Consideration of Comments

Project Name: 2010-14.1 Phase 1 of Balancing Authority Reliability-based Controls | BAL-002-2

Associated Ballot: 2010-14.1 Phase 1 of Balancing Authority Reliability-based Controls BAL-002-2 IN 1 ST

Figure 3: Comparison of Reserve Requirement Calculated on Aggregate vs individual statistics

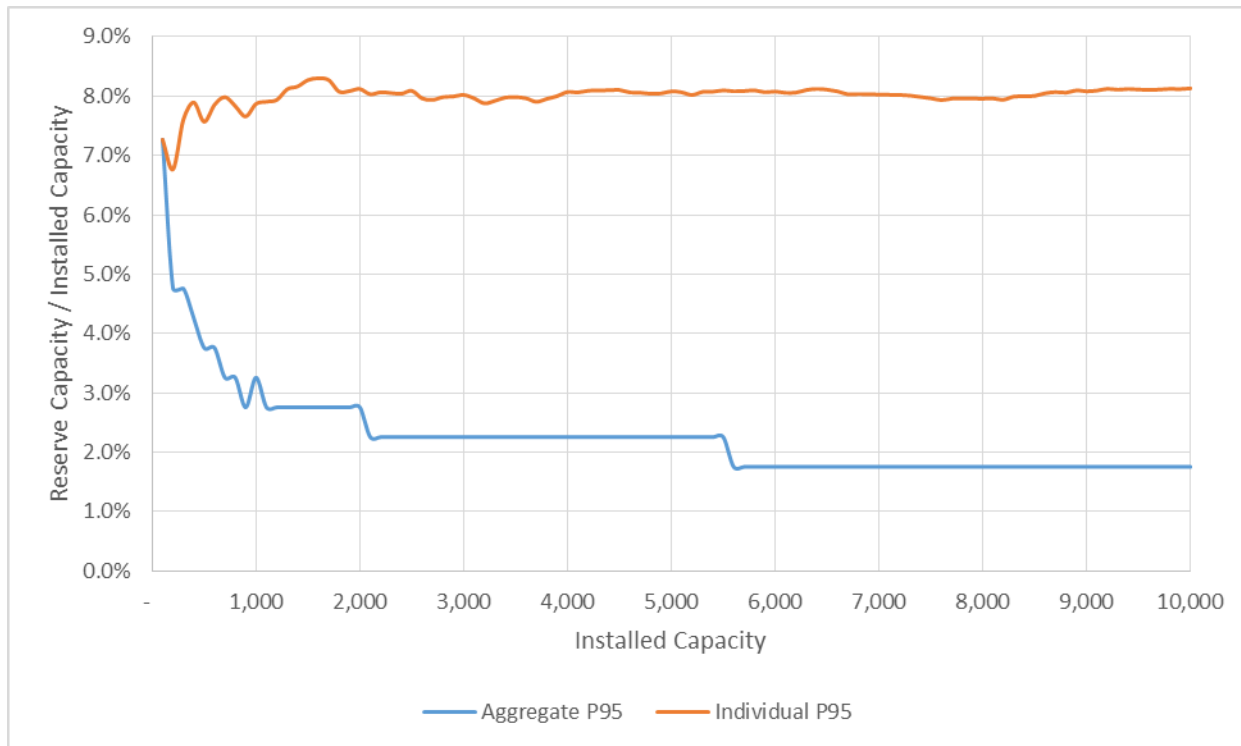
Even if and when an EIM is present, however, it still will likely not adequately resolve the problems from unpredicted loss of generation capability unless designed appropriately. It may still cause individual Balancing Authorities to procure more reserve capacity and related transmission than is required to reliably operate the system as a whole. In discussion regarding implementation of an EIM, a resource sufficiency (RS) methodology is being considered by the NWPP to verify that EIM participants enter the scheduling hour with sufficient resources. The work being done in this respect is thoughtful and important. However, the efforts currently being considered also highlight a gap in the existing system in the west. In order to require that participants come to the market “Firm for the hour”, an analysis of the error frequency distribution associated with a Balancing Authority is being done to evaluate error across the next operating hour, using a persistence forecast from 30 minutes prior to the hour. Required reserve capacity will be determined based on a selected probability of events which would exceed that capacity. This work is ongoing, so it is not clear what the final parameters will be, but a probability of 95% has been examined. This analysis will be done on a Balancing Authority level (as opposed to a system-side/reserve sharing group level), and the result of this calculation will be the required reserve capacity needed to allow participation in the EIM.

The impact of calculating a resource sufficiency for an individual site as opposed to an aggregate system is shown in Figure 3 below. On that chart,

The SDT believes that the loss of predicted generation capability does not impact an entity's ACE. Therefore, the loss of generation capability does not require response in a similar manner to loss of generation. In a loss of renewable generation similar to your example there is no prohibition on the utilization of Contingency Reserve. A change in ACE from the loss of this renewable resource would need to be addressed by an entity experiencing a Reportable Balancing Contingency Event at the same time. As of today, no one has provided a better reserve requirement than MSSC, therefore this is the required reserve recommended in this standard.
